# HISTORIC AND DESIGN REVIEW COMMISSION

**HDRC CASE NO:** 2021-026  
**ADDRESS:** 334 BURLESON ST  
**LEGAL DESCRIPTION:** NCB 519 BLK 24 LOT E 42 FT OF N 134.09 FT OF 8  
**ZONING:** IDZ-1, H  
**CITY COUNCIL DIST.:** 2  
**DISTRICT:** Dignowity Hill Historic District  
**APPLICANT:** cesar sosa/5 ELEMENTS INTERNATIONAL LLC  
**OWNER:** Ruben Lara/5 ELEMENTS INTERNATIONAL LLC  
**TYPE OF WORK:** Construction of a two-story, single-family residential structure  
**APPLICATION RECEIVED:** August 30, 2021  
**60-DAY REVIEW:** Not applicable due to City Council Emergency Orders  
**CASE MANAGER:** Edward Hall

The applicant is requesting a Certificate of Appropriateness for approval to construct a 2-story residential structure on the vacant lot at 334 Burleson, located within the Dignowity Hill Historic District.

**1** LANDSCAPE PLAN  
SCALE: 1/8" = 1'-0"

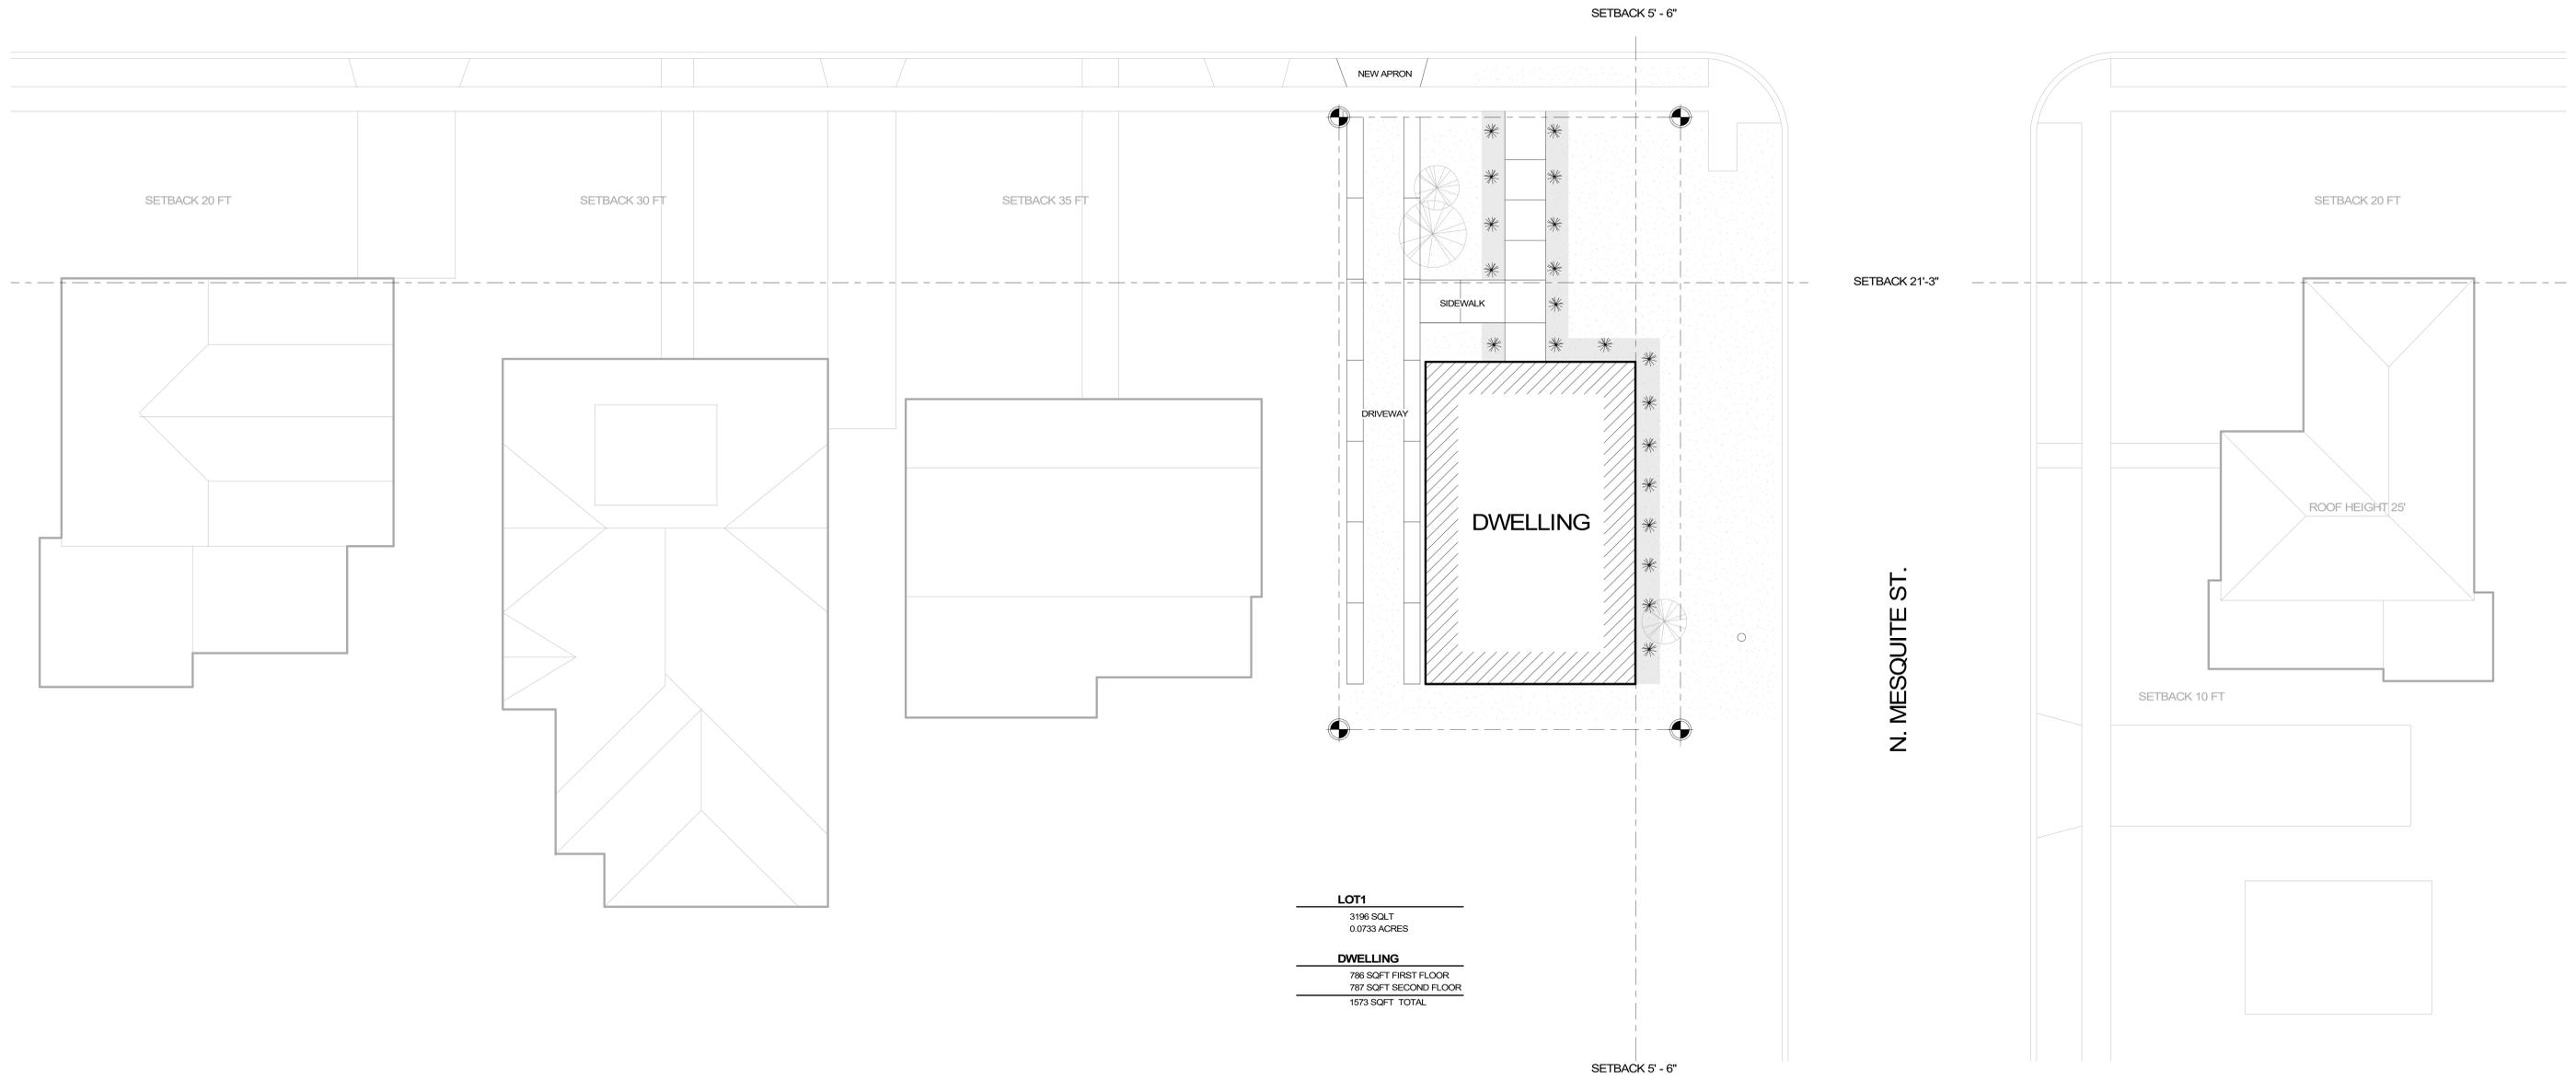
- q. LANDSCAPING – The applicant has proposed natural grass turf throughout. Staff finds the proposed landscaping to be appropriate.
- r. WALKWAY – The applicant has proposed a concrete walkway from the front porch to the sidewalk at the right of way on Burleson. Staff finds the proposed walkway to be appropriate and consistent with the Guidelines.

1 NORTH ELEVATION  
SCALE 1/4" = 1'-0"

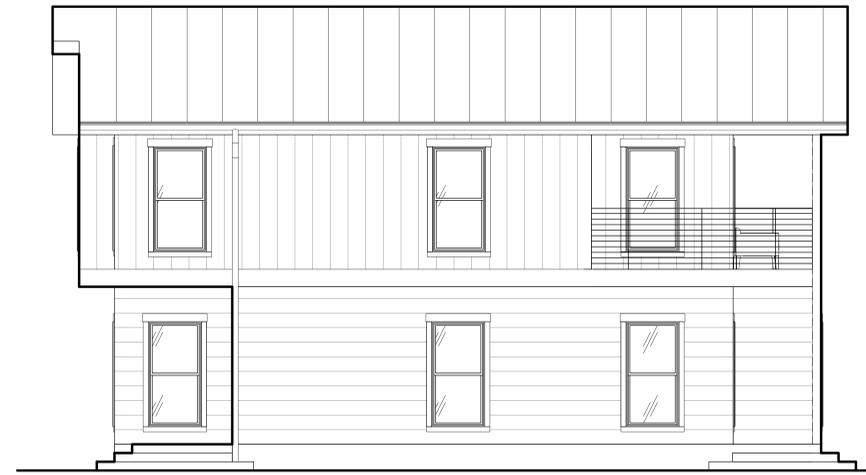
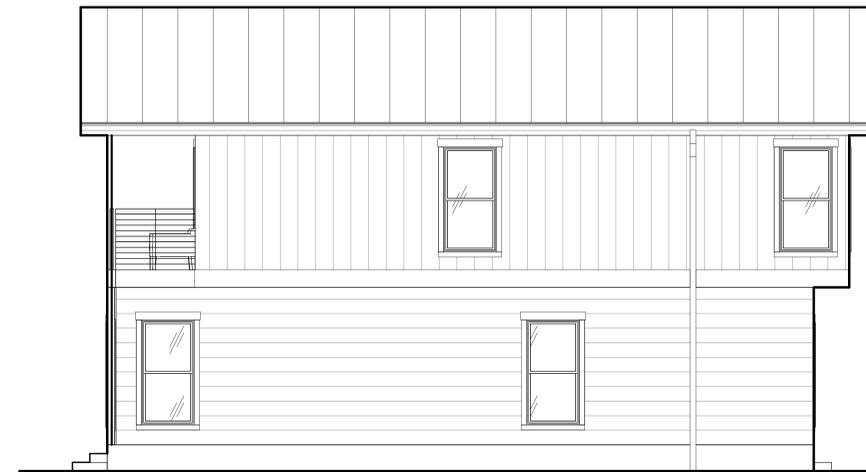
- j. ROOF FORMS – The applicant has proposed a front and rear facing gabled roof. While shallower in pitch than gabled roofs found historically within the district, staff finds the proposed roof form to be generally consistent with the Guidelines.

- l. PORCH – The applicant has proposed a double height front porch to feature massing that is integrated within the overall massing of the proposed new construction. The proposed front porch will also feature a wraparound element. Columns should be at least six (6) inches square. Staff finds that a column detail should be submitted to OHP staff for review and approval prior.

- m. MATERIALS – The applicant has proposed materials that include both wood board and batten and lap siding and a standing seam metal roof. Staff finds that horizontally profiled siding should feature an exposure of four inches and a thickness of ¾”. Board and batten siding should feature boards that are 12 inches wide and battens that are 1 – ½” wide. Siding corners should either be mitered or feature corner trim. The standing seam metal roof should feature panels that are 18 to 21 inches wide, seams that are 1 to 2 inches in height, a crimped ridge seam and a standard galvalume finish. A ridge cap may be submitted for review and approval by the Commission for new construction.

- i. That horizontally profiled siding feature an exposure of four inches and a thickness of  $\frac{3}{4}$ ". Board and batten siding should feature boards that are 12 inches wide and battens that are  $1 - \frac{1}{2}$ " wide. Siding corners should either be mitered or feature corner trim. The standing seam metal roof should feature panels that are 18 to 21 inches wide, seams that are 1 to 2 inches in height, a crimped ridge seam and a standard galvalume finish. A ridge cap may be submitted for review and approval by the Commission for new construction.

- iii. That the proposed driveway does not exceed ten (10) feet in width, as noted in finding p.
- iv. That the proposed columns feature six (6) inches square with capital and base trim.
